**PLAN COMMISSION / ZONING BOARD OF APPEALS  
AGENDA**

**Project:** Sparks Coffee Co. – New Construction  
**Meeting Type:** Public Hearing  
**Request:** Major change to PUD, Special Use Permits (4)  
**Location:** Hickory Creek Marketplace, Outlot 1E  
**Applicant:** Aliana Winkle  
**Prop. Owner:** Winkle R E Properties  
**Representative:** Applicant  
**Staff report by:** Christopher Gruba, Senior Planner

## **Major changes to plans since workshop**

③ SECTION5  
1/4" = 1'-0"

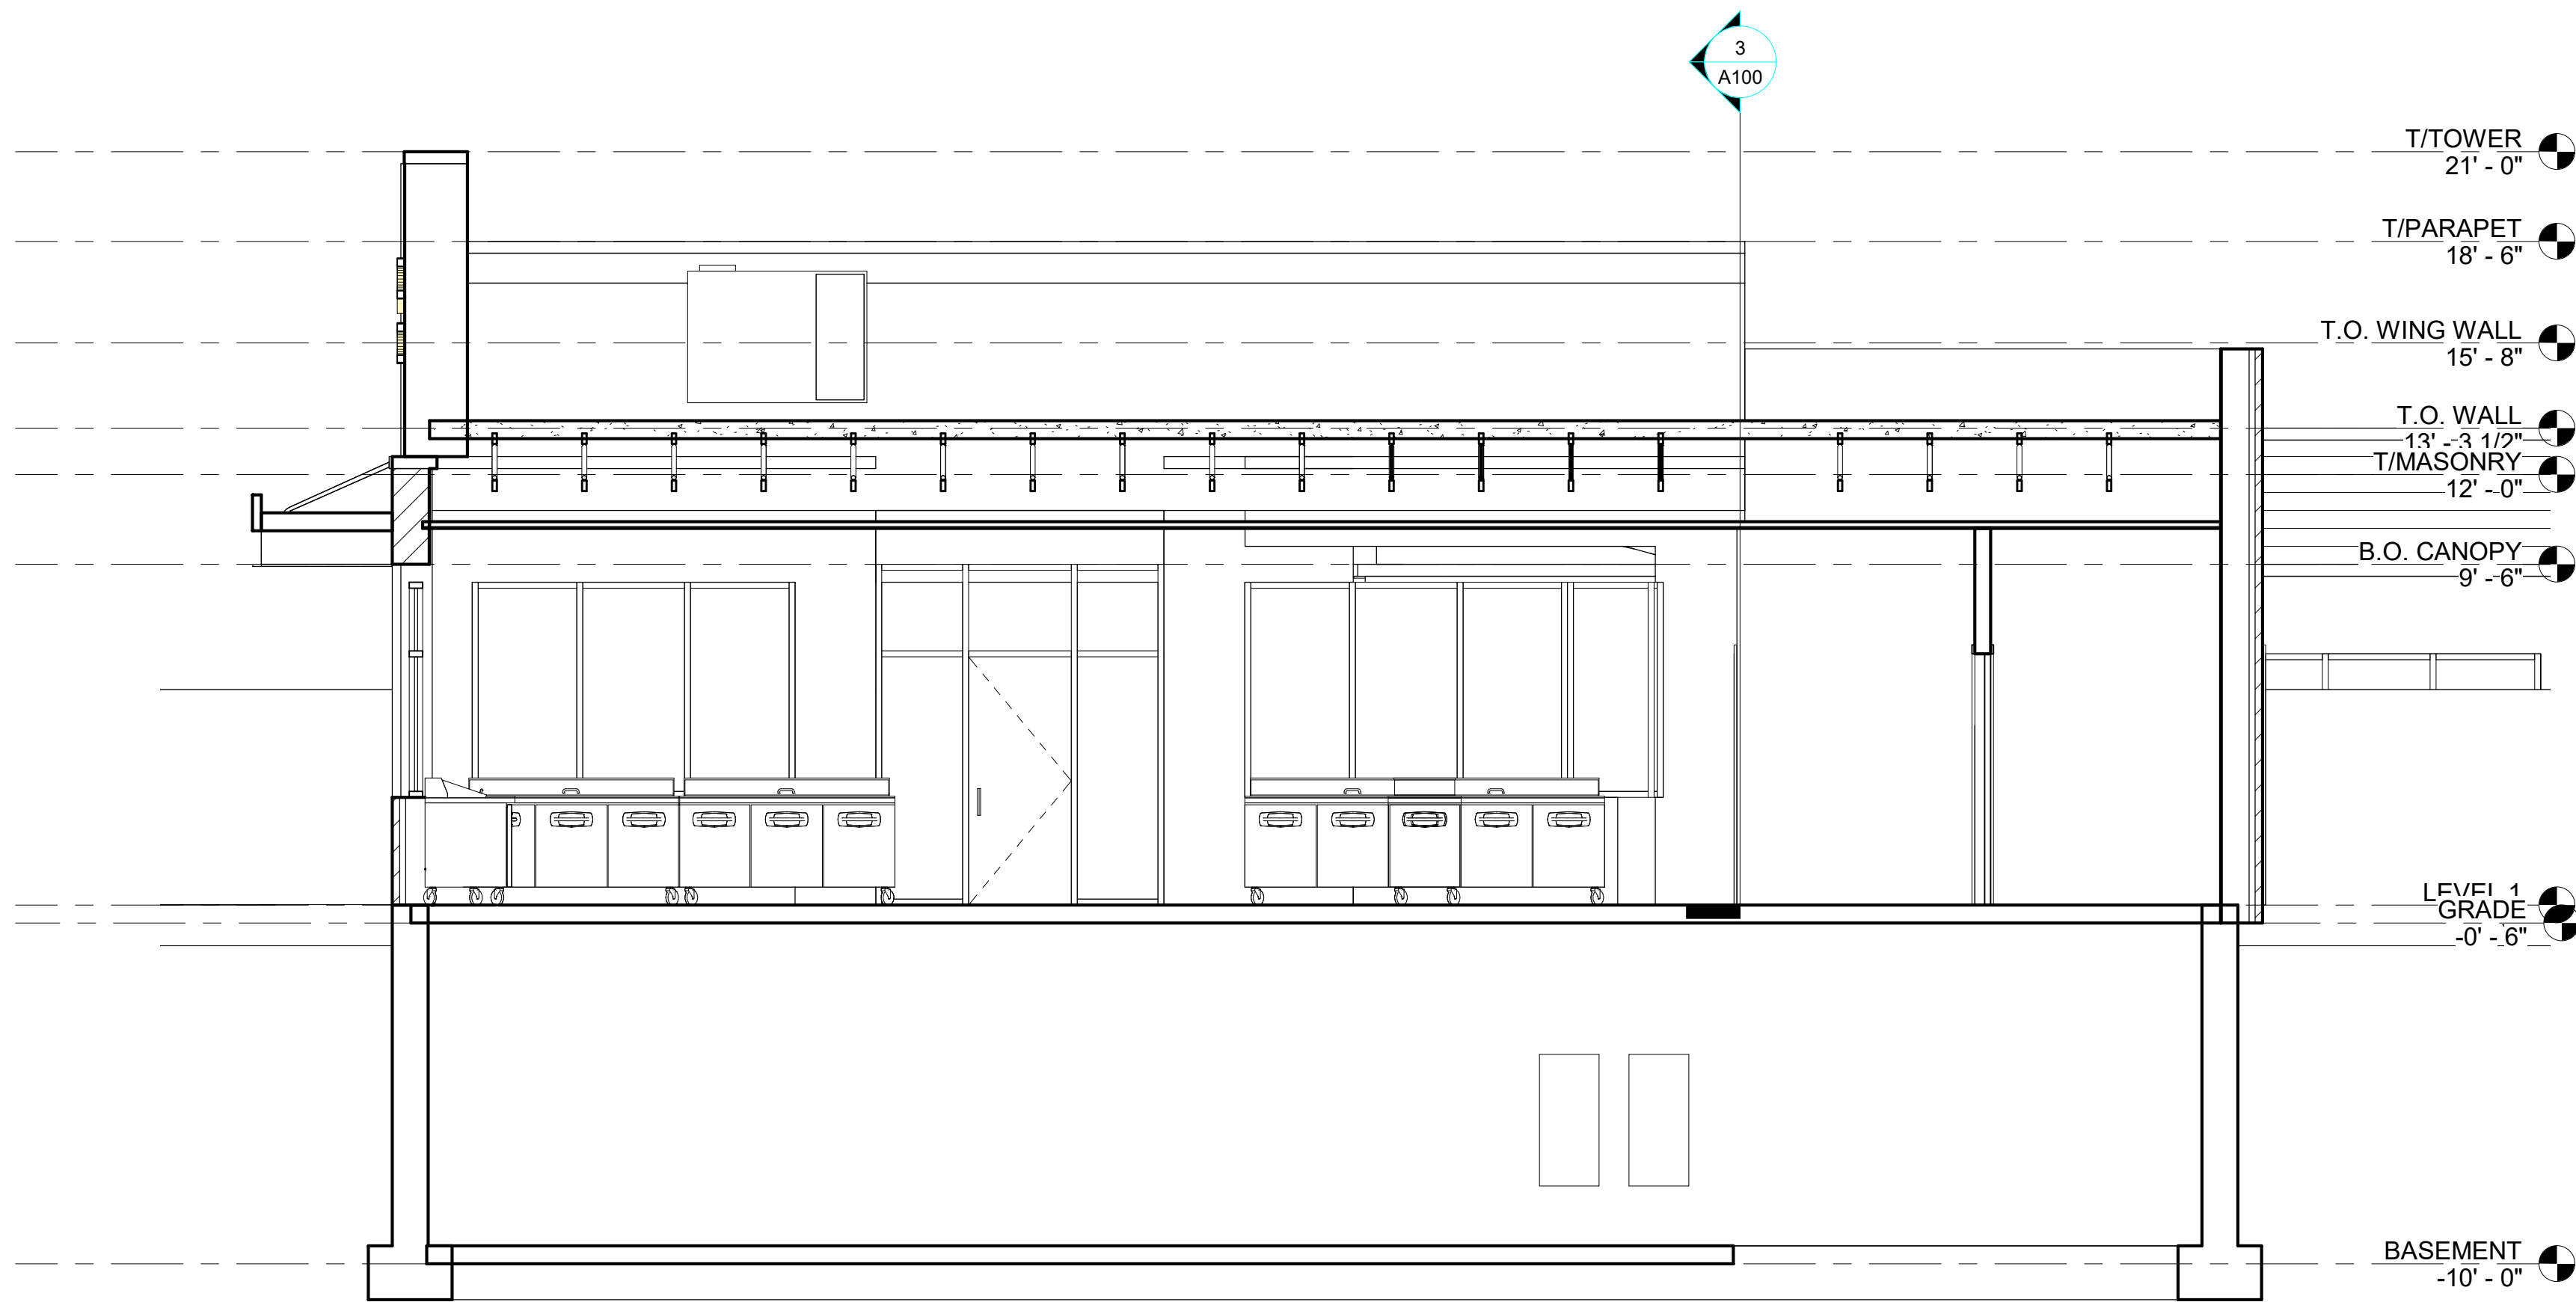
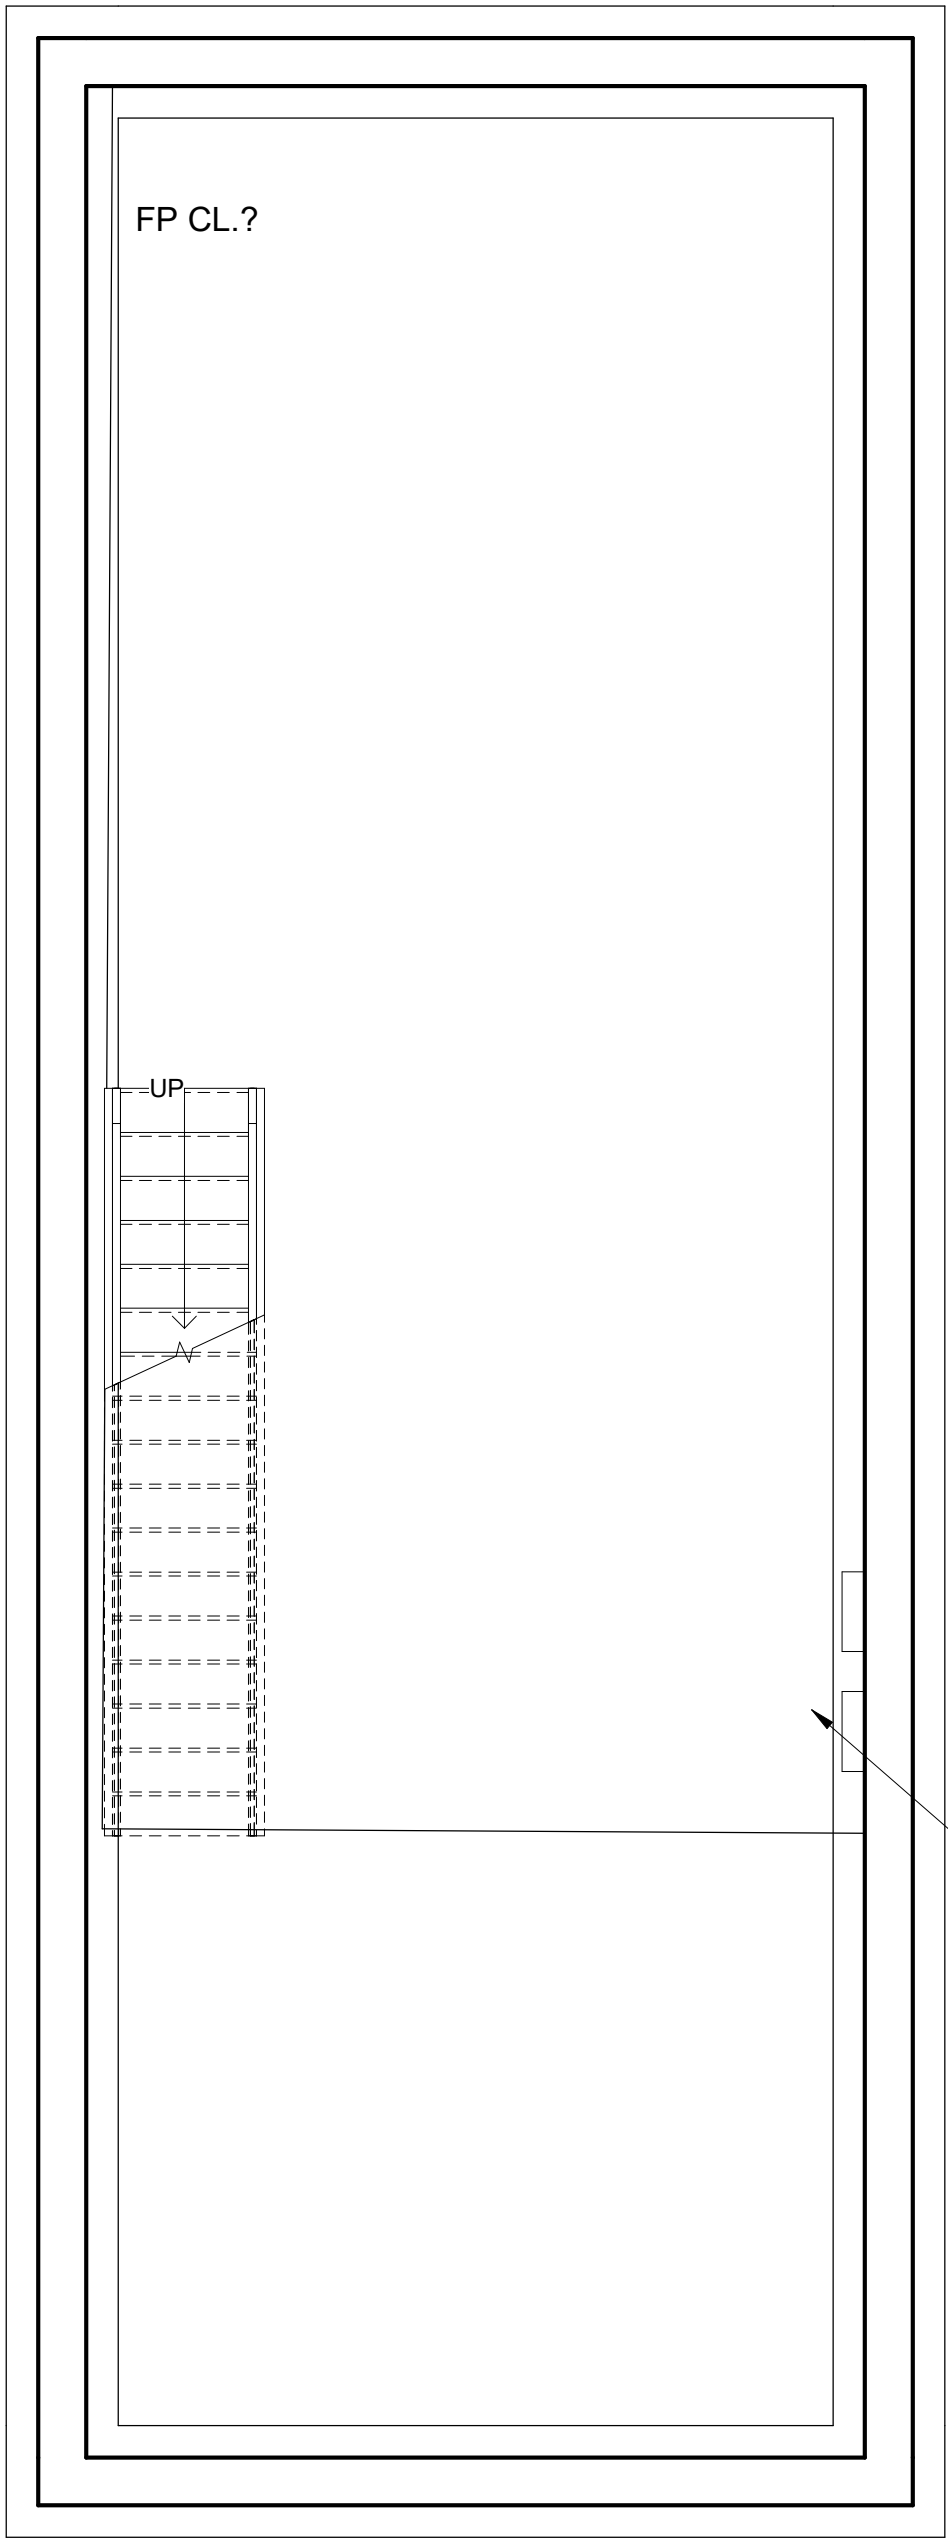
4. A full basement is proposed as illustrated on Sheet A101. Although not defined on the floorplan, it was stated by the applicant at the workshop meeting that the basement will be used for storage.
